#### **Addendum 103 – Regulation No. 104**

#### **Revision 1 - Amendment 2**

Supplement 8 to the 00 series of amendments – Date of entry into force: 15 June 2015

#### **Uniform provisions concerning the approval of retro-reflective markings for vehicles of category M, N and O**

"Figure 1  
**Retro-reflective material marking of Class F**

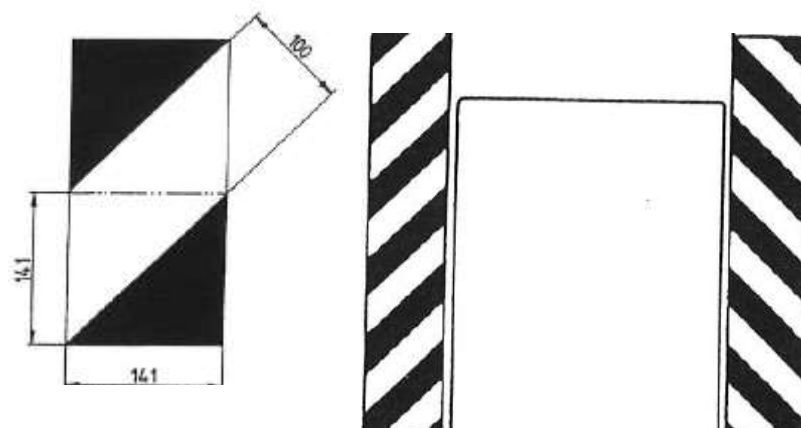
2.2.1. Class F retro-reflective materials shall consist of red and white diagonal stripes each 100 mm wide sloping outwards and downwards at 45°. The basic standard area is a square of 141 mm in length subdivided diagonally into a white half and red half, which represents one standard area as shown in Figure 1.

2.2.2. The minimum length of an element of a retro-reflective marking material shall incorporate a minimum of 9 standard areas as described in paragraph 2.2.1. above on large vehicles with available mounting space, but may be reduced to a minimum of 4 standard areas on vehicles with limited mounting space."

*Insert a new Figure 1 to read:*
